ENGINEERING CHANGE PROPOSAL

ECP NUMBER BC-M/O-3742	TITLE Bayou Choctaw Phone Line to VSAT Conversion																	
BUDGET SOURCE <input type="checkbox"/> SPR BLI <input type="checkbox"/> CONTRACTOR BASELINE <input type="checkbox"/> BCR <input type="checkbox"/> OTHER	AUTHORITY <input checked="" type="checkbox"/> PCCB <input type="checkbox"/> ECC																	
	SCHEDULE <input type="checkbox"/> YES MILESTONE NUMBER CMCR NUMBER <input type="checkbox"/> NO	TOTAL ESTIMATED COST OF CHANGE

ECP NUMBER BC-M/O-3742	ECP TITLE Bayou Choctaw Phone Line to VSAT Conversion	PAGE 1 OF <u>1</u>
----------------------------------	---	--------------------

EQUILON PIPELINE	
TYPICAL VSAT INSTALLATIO	
SCALE NONE	DATE REF.
DRAWN DPM	
CHECKED ROBERT SMITH	01/31/02 SA-XXXXX
APPROVED	
REV. APP.

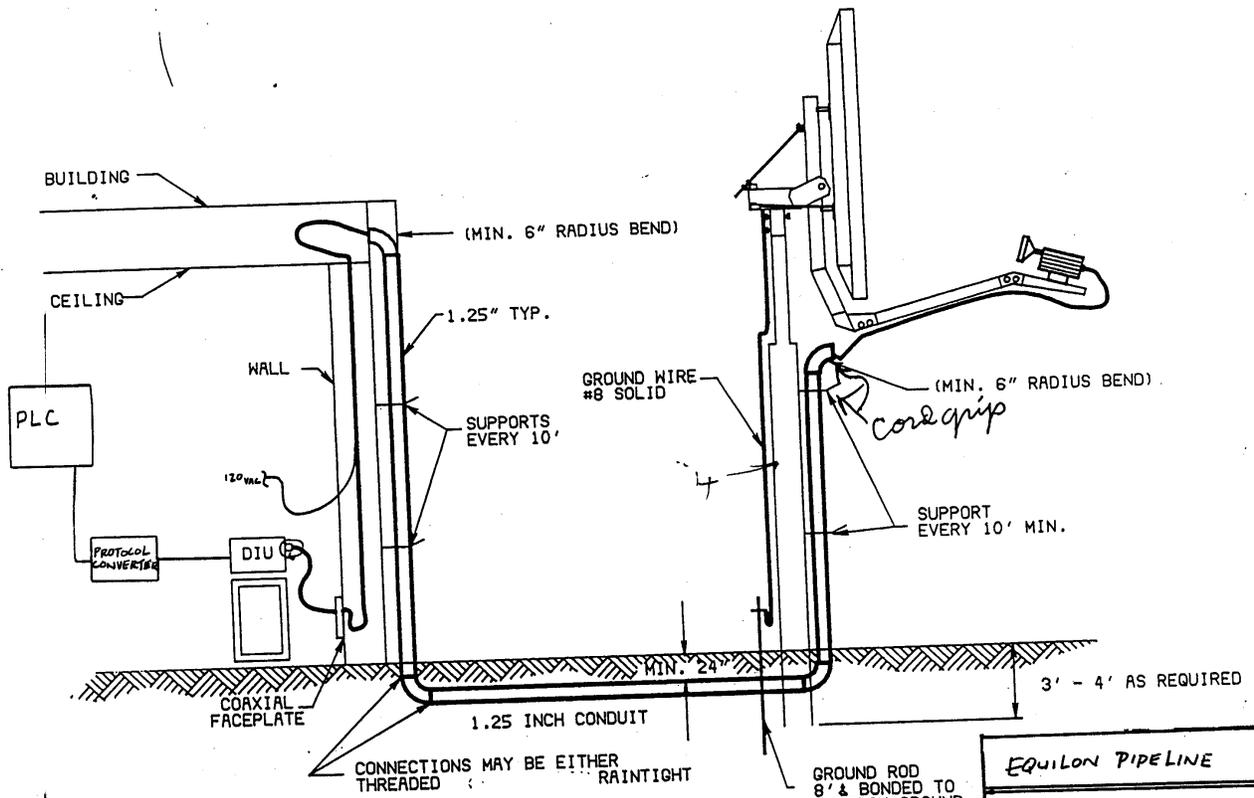
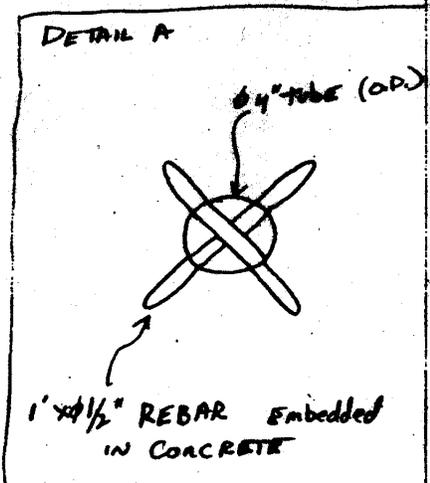
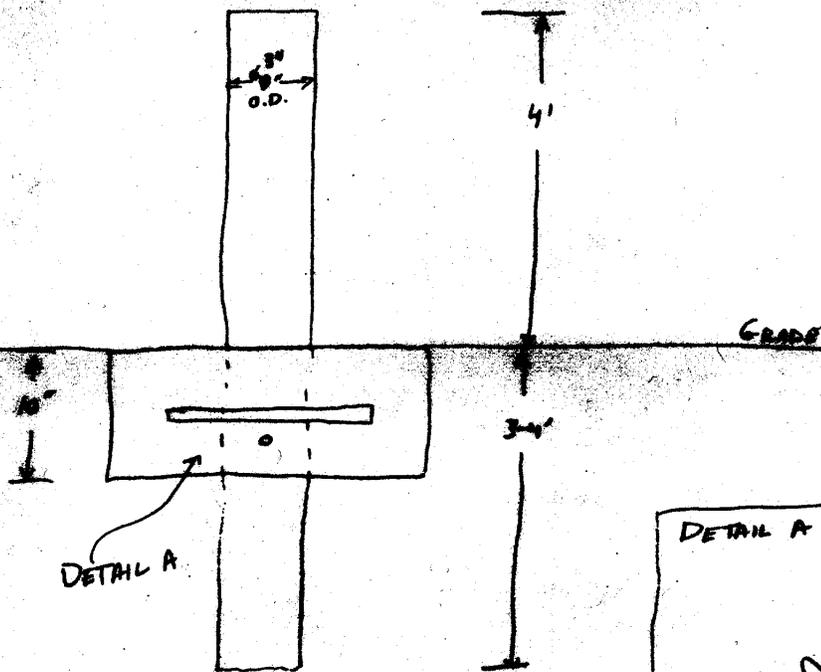
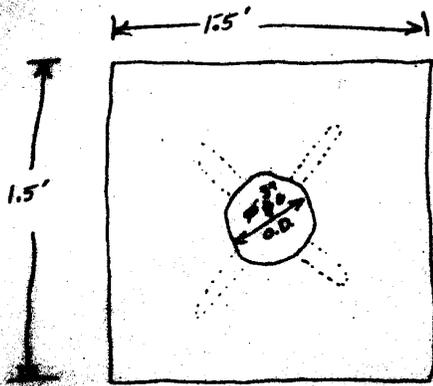
DESCRIPTION:
 PROBLEM / EXISTING CONFIGURATION
Equilon's Houston-based Control Center currently operates this facility via a 4 wire dedicated phone circuit. This phone circuit has proven to be unreliable and expensive to maintain. Equilon's proposal is to replace the phone connection with a satellite dish (VSAT).
Expected start date for the project is 04/01/02.
Installation cost estimate includes:

PROPOSED SOLUTION / ENHANCEMENT
Equilon Pipeline would install satellite communications at this location. This is becoming the standard method of RTU installation for the company. Existing operations at the location would not be changed. The data would be shipped back to the Houston Control Center via satellite rather than by phone wire.

- NOTE:
- IN AREAS WHERE A DISH HEATER IS REQUIRED, A SEPERATE RUN OF CONDUIT WILL BE REQUIRED TO POWER THE HEATER.
 - ALL CONDUIT SHALL BE RIGID METAL CONDUIT (1.25 INCH FOR IFL CABLE 3/4" FOR HEATER WIRE) Install conduit with pull string
 - IN BUILDINGS WITH NO INTERIOR WALLS, COAX SHALL BE IN CONDUIT
 - GROUND WIRE TO BE BONDED TO STATION GROUND GRID
